Q10 HIP INSERT INSTALLATION

GRSP IG Child Restraint Systems
August 31, 2017

Q10 Hip liner

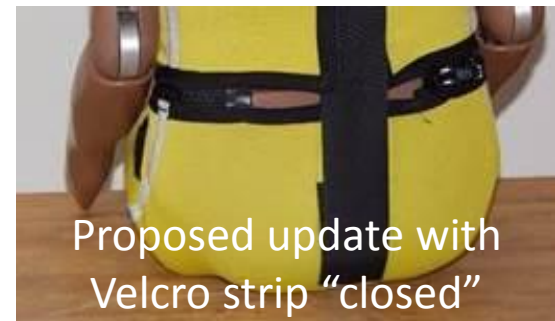
- Hip insert introduced to prevent belt getting trapped in opening between pelvis and thigh
 - Accepted in R129 (Q3, Q6 and Q10) and Euro NCAP 2018 (Q6 and Q10)
- Humanetics received feedback that the Q10 hip inserts are difficult to install

- Zipper and Velcro strap stitched to upper rim of trousers
- Both items limit stretch of the trousers fabric along the top side
- Shortening the Velcro patch on the trousers provides sufficient flexibility / stretch in the trousers to easily install the hip insert
 - Does not affect fitting of trousers
 - Remaining Velcro area is sufficient to attach as before proposed change
 - Change can easily be done by dummy owners
 - Humanetics to provide instructions in Service Bulletin
